### 7913G – Trinity, Huddersfield

WML Consulting have received comments relating to planning application no. 2024/90464 from Natalie Heaney of Kirklees Council via email on 31<sup>st</sup> May 2024. Please find the additional information requested below in italics.

Title  
**EXPLORATORY HOLE LOCATION PLAN**

Job No. **7913G** Drawing No. **SK-01A**

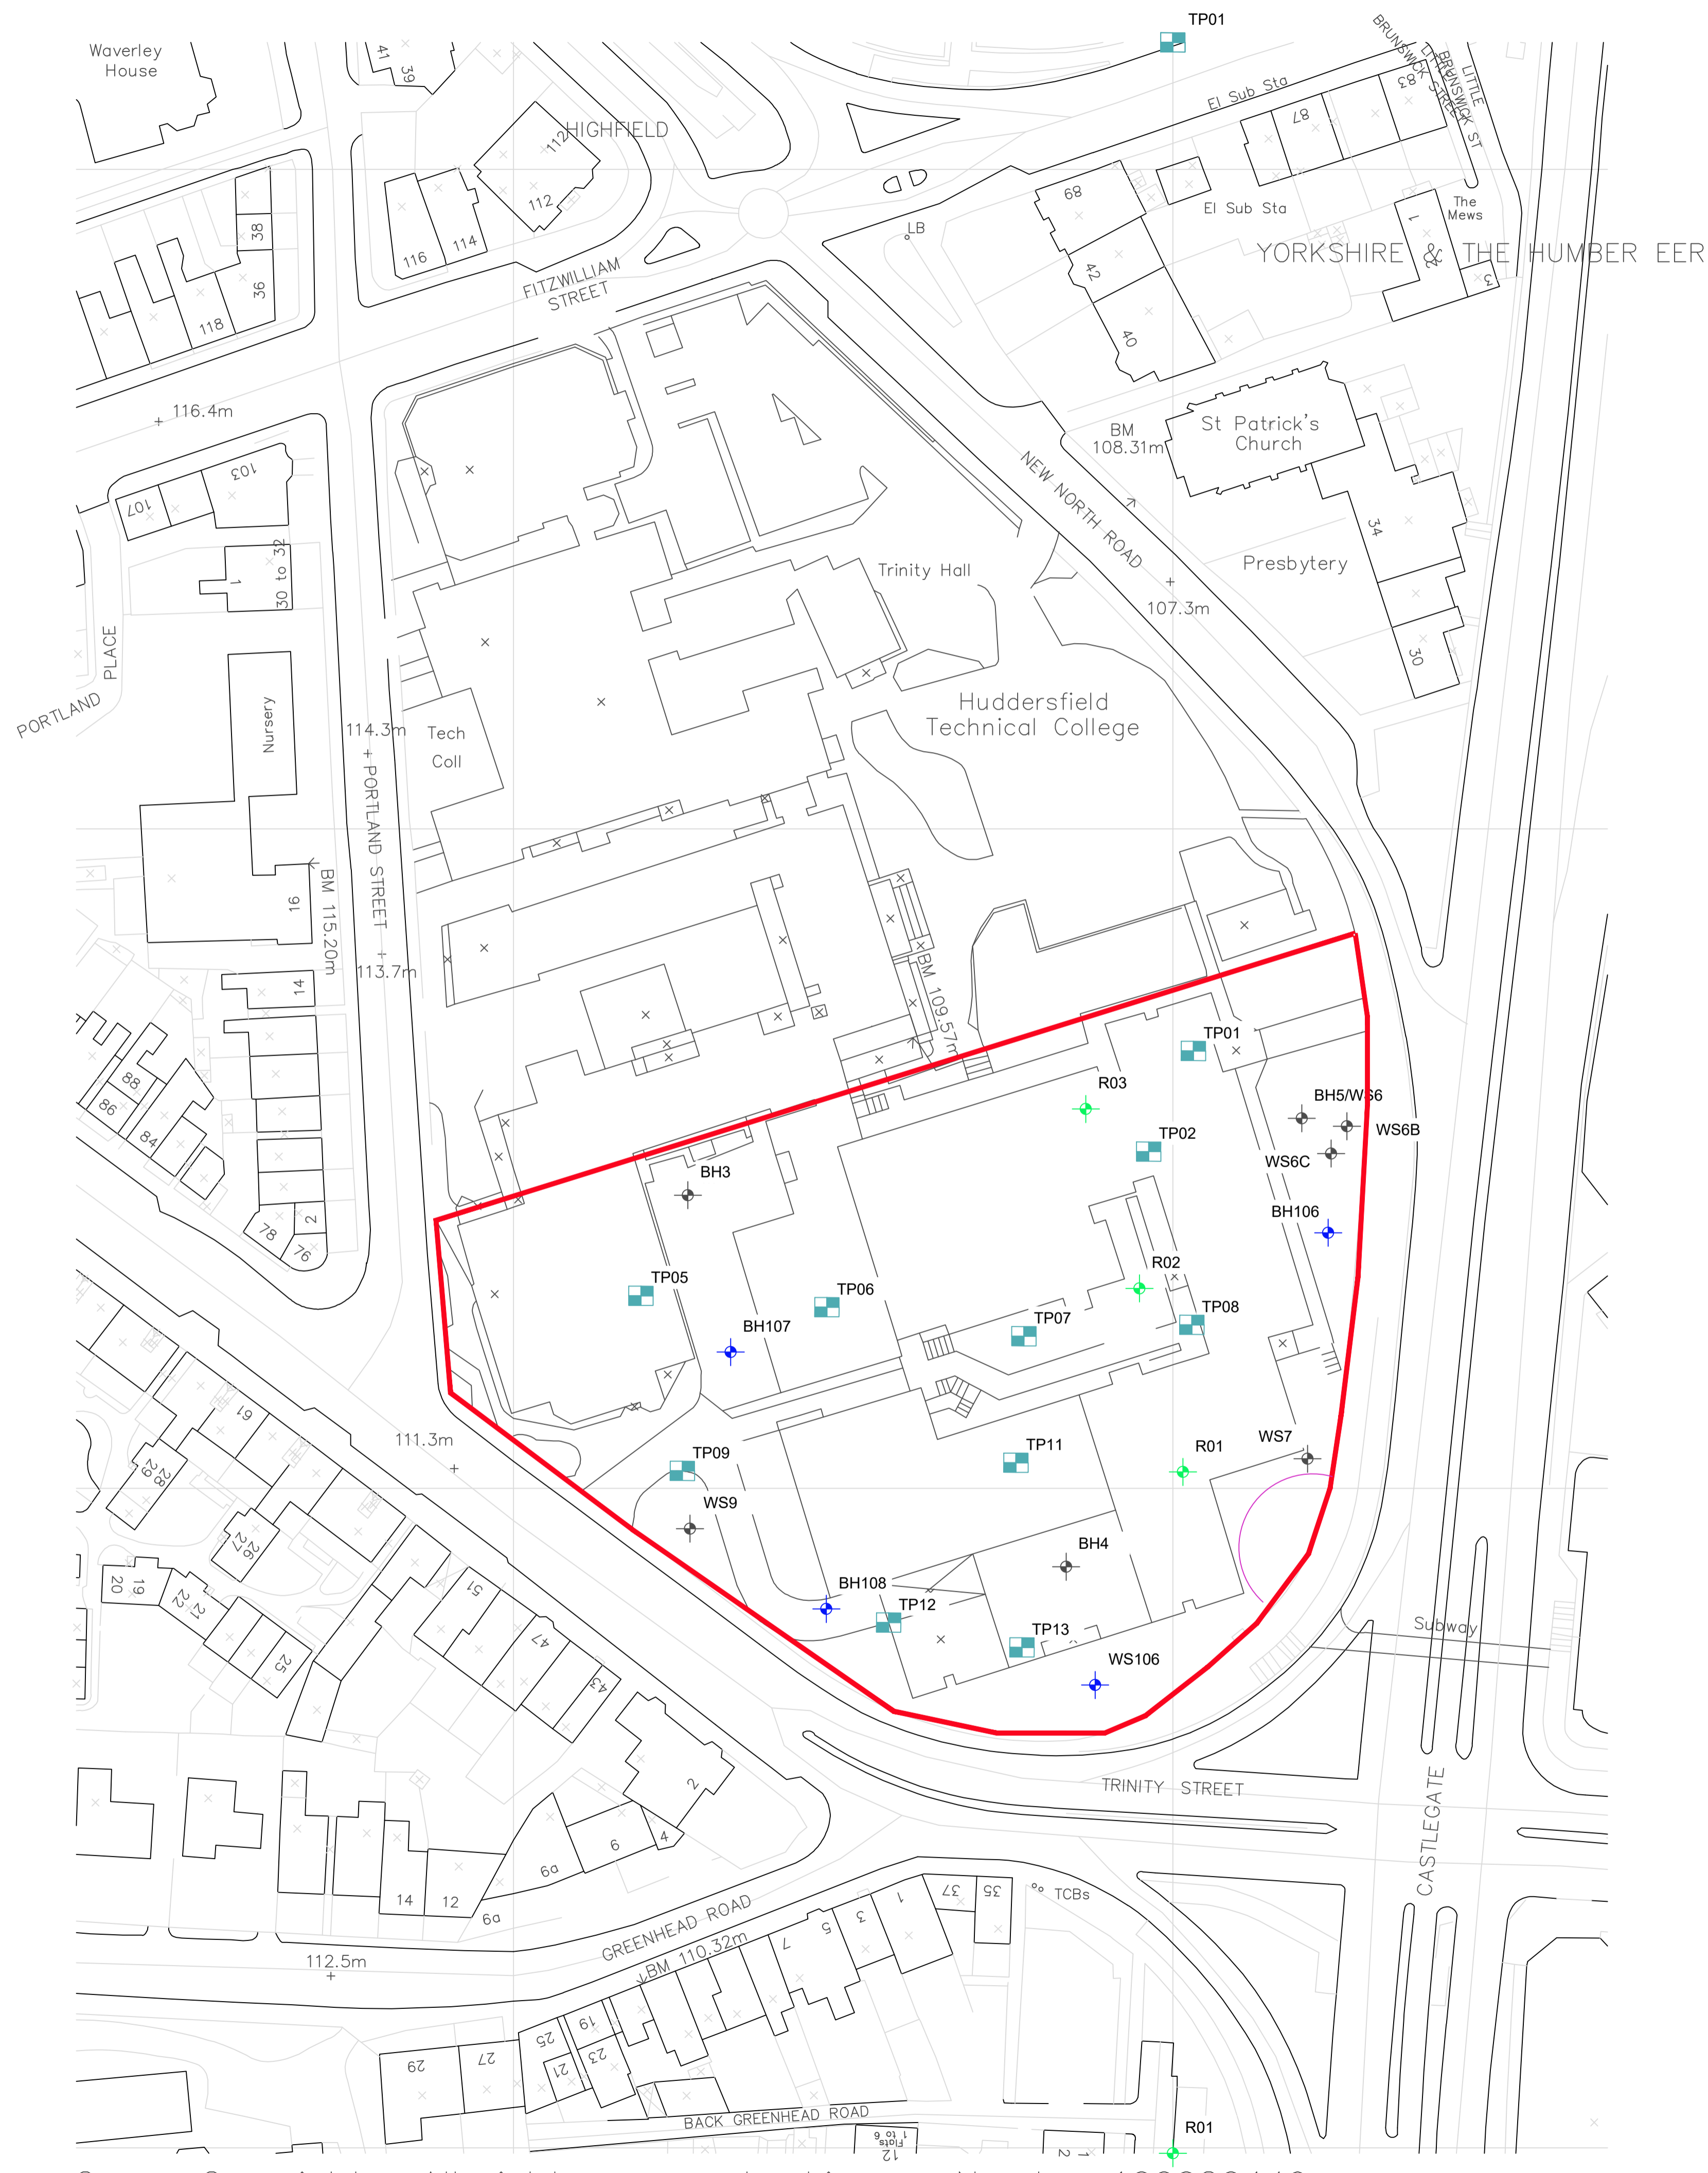
1. Env Health sought clarification on the gas monitoring data set, and in particular requested pressure trend information, additional commentary on the response zones and the targeted strata, sampling times of the standpipes and the number of boreholes in the southern area as there appears to be a discrepancy.

In total 7no exploratory holes have been monitoring which are located in the southern part of the site. Soil Mechanics 2006 WS7 & WS9 had been mistakenly omitted from the combined location plan in the Phase 2 report, an updated plan with these positions shown is appended (7913G SK-01A).
